Access Compliance Report

Public Rights-of-Way

(Curb Ramps)

Intersection ID: 31884	Main Street: CENTERLINE_DR	Cross Street: LIFELINE_LN	Location: SE
ADA ID: A8FAEF7CF110	Ramp Type: PerpDiag	Initial Pass/Fail: Fail	Overall Compliance: No
Codes/Mitigation Info/Possible Solution		Field Measurements/Component Compliance	
Severity Score: 21.25

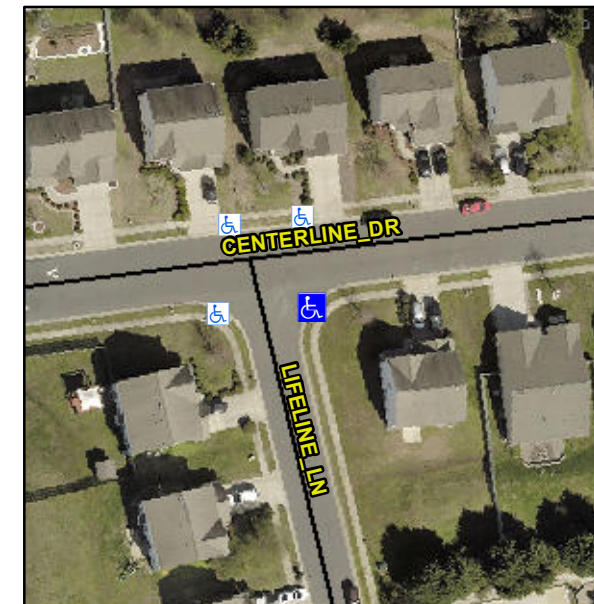
Not Found, R304.5.1, R304.5.3

Compliance	Description	Data	Compliance	Description	Data
N/A	Ramp Length (in)	47.0	Yes	Ramp Slope (%)	5.0
No	Ramp Width (in)	44.5	No	Ramp XSlope (%)	5.9
N/A	Flare Type LT	N/A	N/A	Flare Type RT	N/A
N/A	Flare Slope LT (%)	N/A	N/A	Flare Slope RT (%)	N/A
N/A	Flare Traversable LT?	N/A	N/A	Flare Traversable RT?	N/A
N/A	Landing Length (in)	N/A	N/A	DWS Provided?	N/A
N/A	Landing Width (in)	N/A	N/A	DWS Contrast?	N/A
N/A	Landing Slope (%)	N/A	N/A	DWS Length (in)	N/A
N/A	Landing X Slope (%)	N/A	N/A	DWS Full Width?	N/A
N/A	Landing Curb? (Y/N)	N/A	N/A	DWS Offset (in)	N/A
N/A	Shared Landing?	N/A			
N/A	Gutter Ponding?	N/A	N/A	Gutter Slope (%)	N/A
N/A	Gutter Lip Ht (in)	N/A	N/A	Gutter X Slope (%)	N/A
N/A	Painted X Walk1?	No	N/A	Painted X Walk2?	No
	X Walk 1 Direction	To N		X Walk 2 Direction	To W
N/A	X Walk 1 Width (in)	N/A	N/A	X Walk 2 Width (in)	N/A
	X Walk 1 Slope (%)	3.6		X Walk 2 Slope (%)	1.6
	X Walk 1 X Slope (%)	2.4		X Walk 2 X Slope (%)	2.0

Remove & Replace Curb Ramp With Two New Directional Ramps or Equivalent.
